**siegel design**
architects LLC 1006 Park Avenue SW Albuquerque NM 87102 505 243 4501 505 243 4504 fax

Letter of Justification
**RE: AMENDMENT TO SITE DEVELOPMENT PLAN FOR BUILDING PERMIT**
Previous File No. Z-71-34-1 dated/approved July 7, 1987.
LOT 7, Tramway Ridge Addition
4841 Tramway Ridge NE
Albuquerque, New Mexico

DEVELOPMENT REVIEW BOARD--SPEED MEMO

NOTIFICATION OF DECISION

REFUSE ELEVATIONS

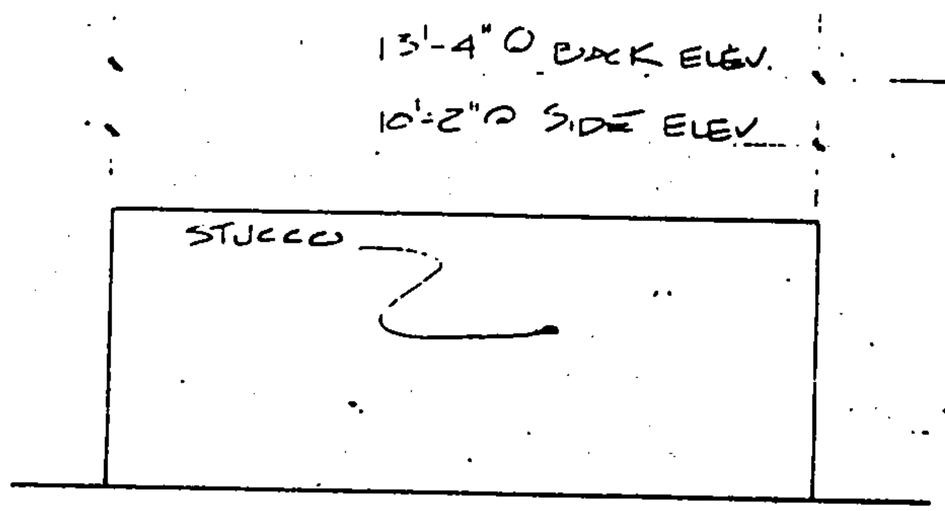
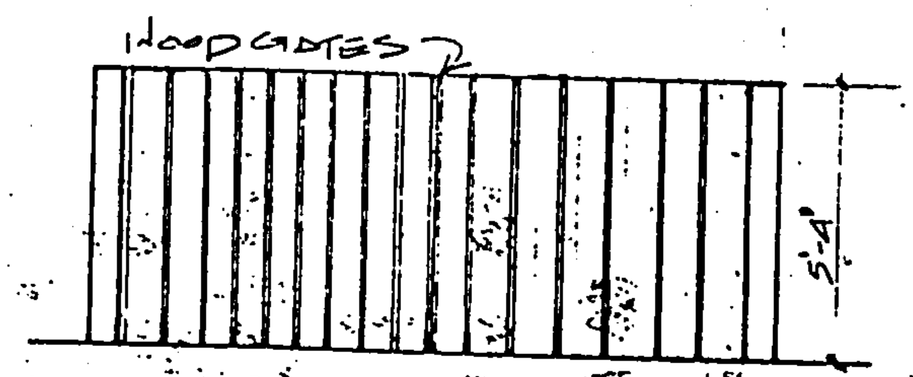
2. TRASH ENCLOSURE should be built of masonry matching [illegible].

2. Elevations of the trash enclosure must be approved to the satisfaction of staff.
